ASSESSMENT REPORT

1 Lawson Square, Redfern SSD 5249 MOD 3

Figure 10: Proposed eastern and western elevation of Tower 1 (Source: Plans MOD 3)

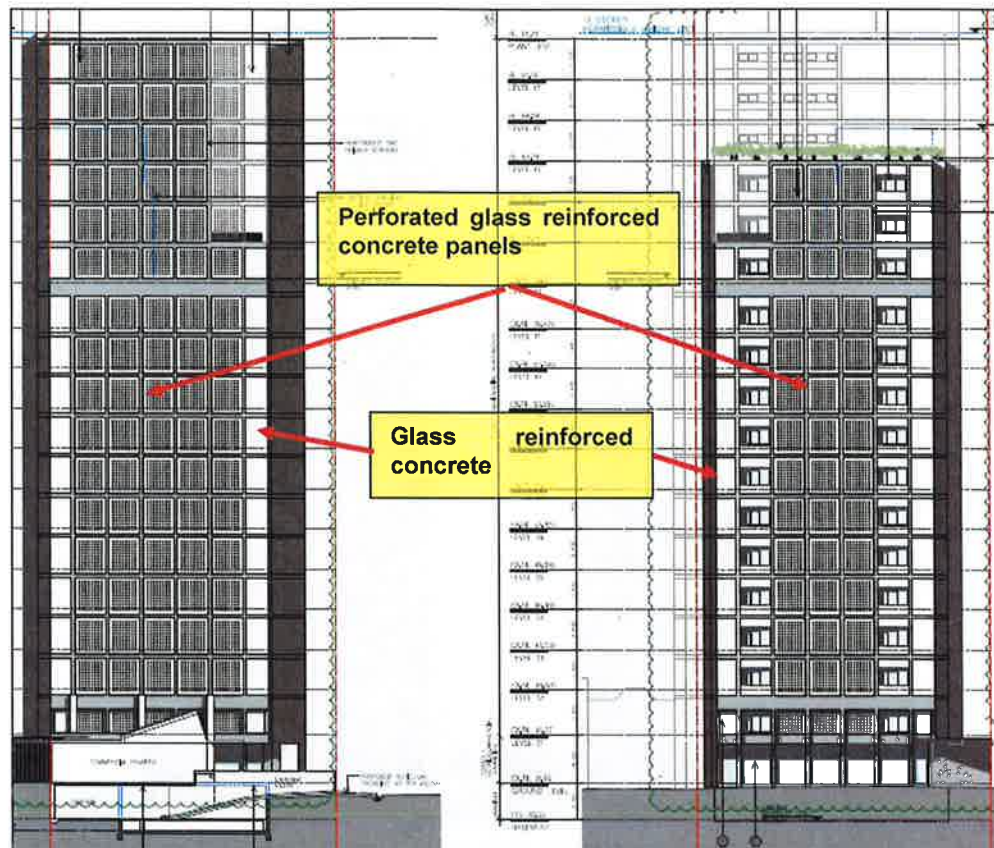
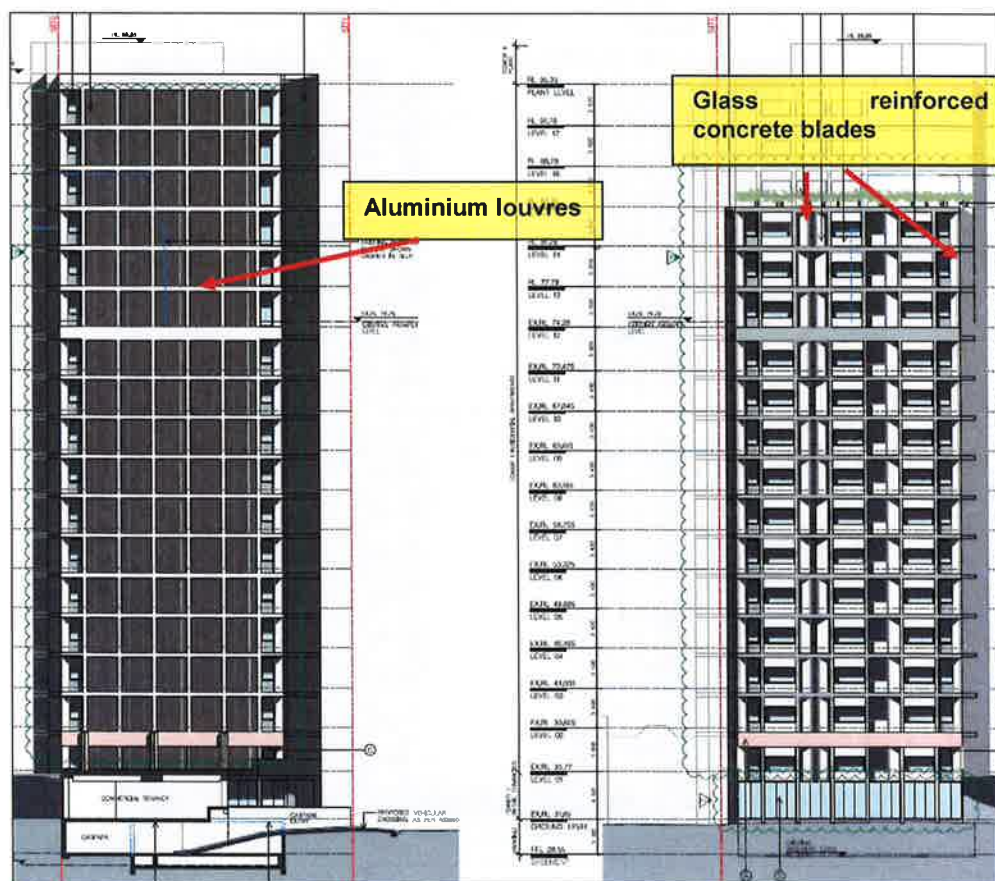
The approved perforated glass reinforced concrete screens are proposed to be replaced with glass reinforced concrete blades and aluminium louvres on the eastern and western facades of both of the towers (**Figures 9 and 10**). The changes would open up the facades of the towers and improve the internal amenity of the apartments by providing additional sunlight and views. The Department considers the changes to the towers would provide greater articulation and improved architectural expression and are therefore supported.

Figure 12: Proposed southern elevation of Towers 1 and 2
(Source: MOD 2)

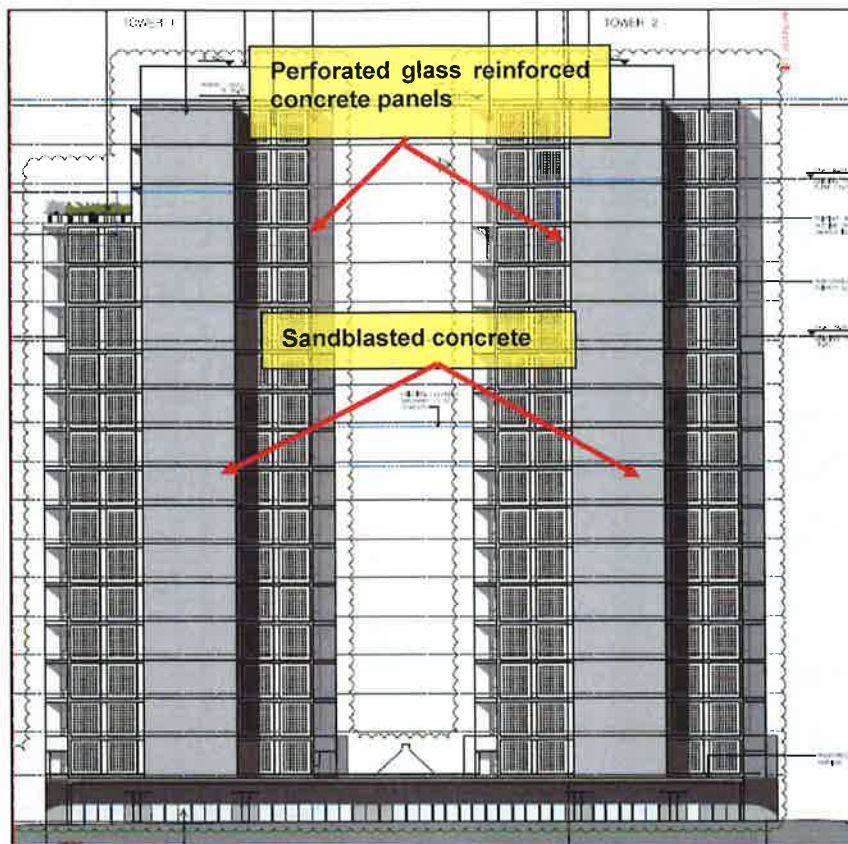
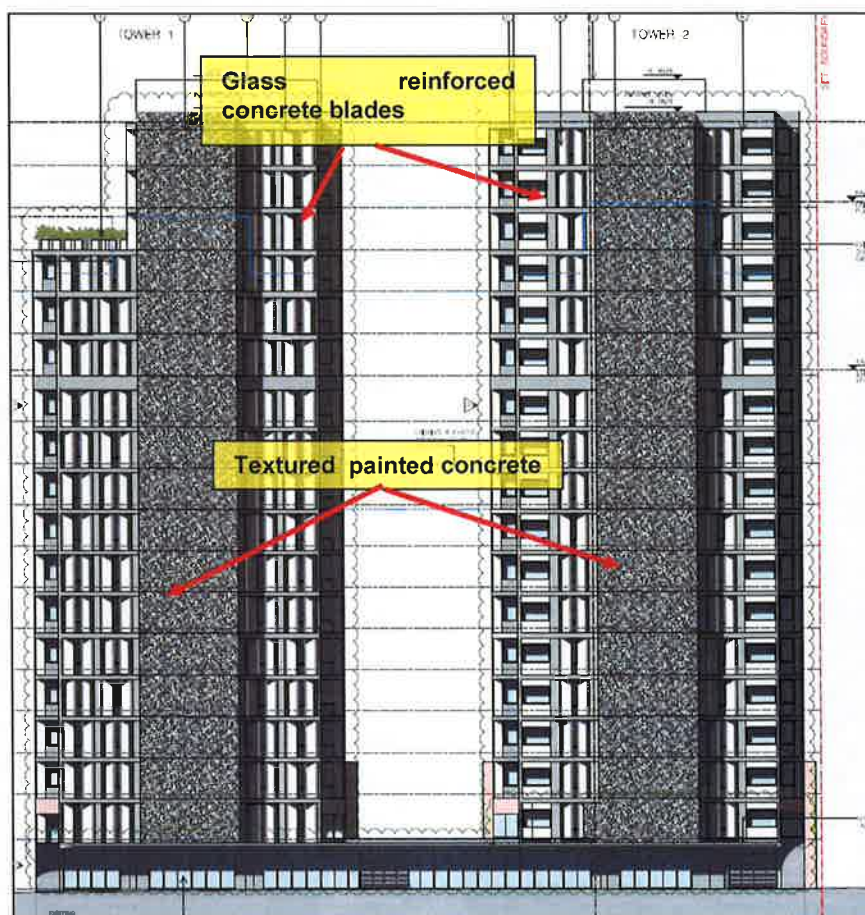
On the southern façade of the towers, the perforated glass reinforced concrete panels and sandblasted concrete would be replaced by glass reinforced concrete blades, glazing and textured painted concrete respectively (**Figures 11 and 12**). The Department considers the removal of the glass reinforced concrete panels would improve the articulation of the southern facades of the towers and provide greater vertical expression. This would act to reduce the façade's massing and improve the towers' proportions and visual appearance. The replacement of the sandblasted concrete with a textured maintained concrete would complement the overall palette of materials and maintain the overall aesthetic quality of the towers.

Figure 13: View lines between Tower 1 and 157 Redfern Street (Source: EIS for MOD 3)

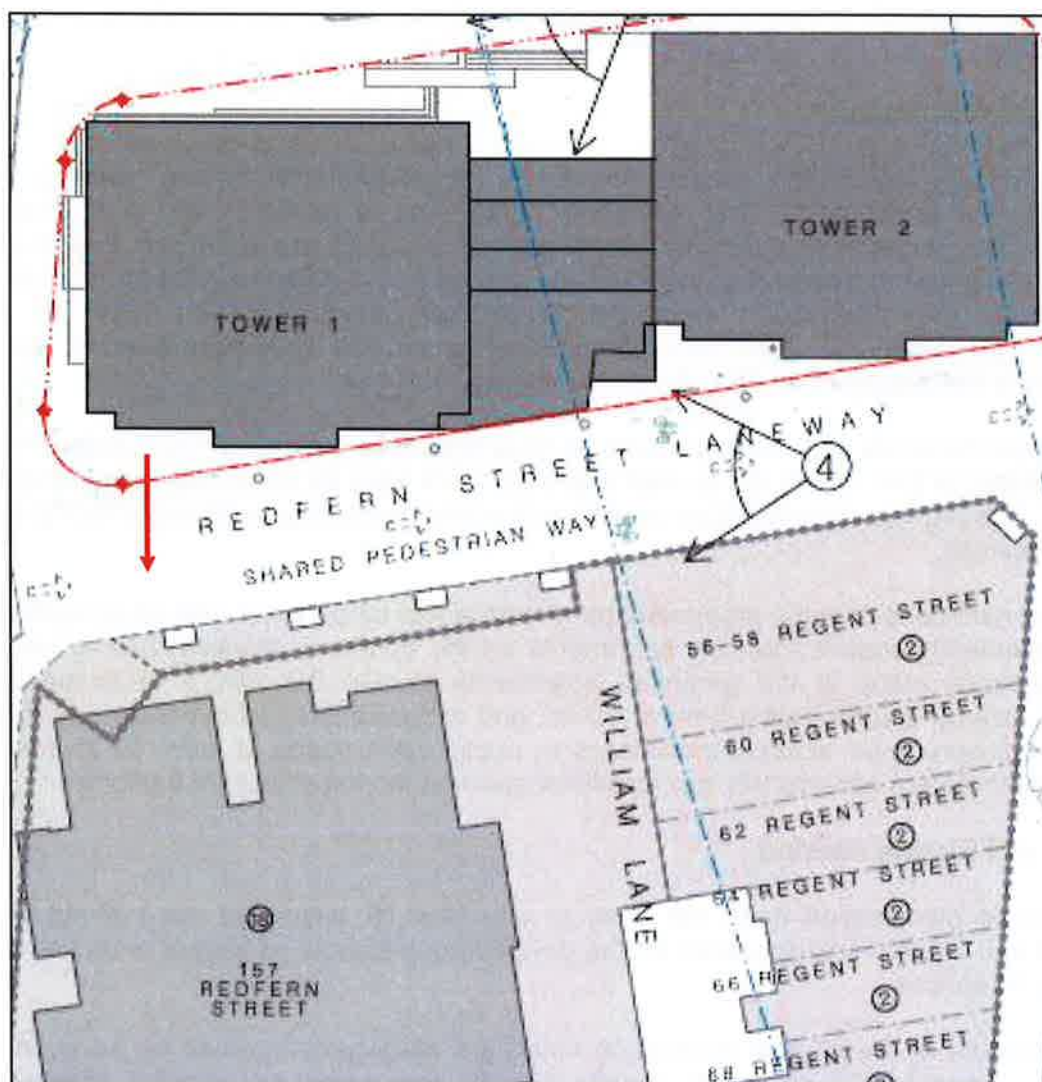
The modification seeks to remove the perforated glass reinforced concrete panels which face the southern residential apartment building at 157 Redfern Street. A public submission was received regarding privacy impacts from the south-facing windows of the western tower (Tower 1) to the north-facing apartments of 157 Redfern Street. The public submission raised concerns about the apartments in Tower 1 having bedrooms, living rooms and kitchen windows located to the south which would increase the potential for overlooking between the southern façades of Tower 1 and 157 Redfern Street.

The view lines between Tower 1 and 157 Redfern Street are identified at **Figure 13** below.

In its RtS, the Applicant provided further information and clarification regarding privacy impacts between Tower 1 and 157 Redfern Street and outlined:

- the rooms on the southern elevation are bedrooms, bathrooms and corridor/study areas, with kitchen, dining and living rooms orientated to the east or west to avoid overlooking residents to the south
- the bedrooms on the southern elevation have opaque glass reinforced concrete blades fixed to the windows to prevent overlooking, which are angled away from 157 Redfern Street
- the bathrooms on the southern elevation have opaque glass windows and panels which will prevent overlooking
- it is only the corridor/study areas which have a small window facing south and these windows are already approved under MOD 2.

The Department considers the use of glass reinforced concrete blades and aluminium louvres which are appropriately glazed and angled, ensure that a reasonable level of privacy would be maintained to the adjacent residents at 157 Redfern Street. Additionally, the changes proposed to the layout of apartments on the southern elevation would ensure that living areas are orientated away from the south to mitigate overlooking potential. The Department further notes the residents at Tower 1 and 157 Redfern Street are separated by approximately 17.1 m which also mitigates overlooking potential.

The Department concludes the proposed development would maintain acceptable levels of privacy to the residents of 157 Redfern Street.
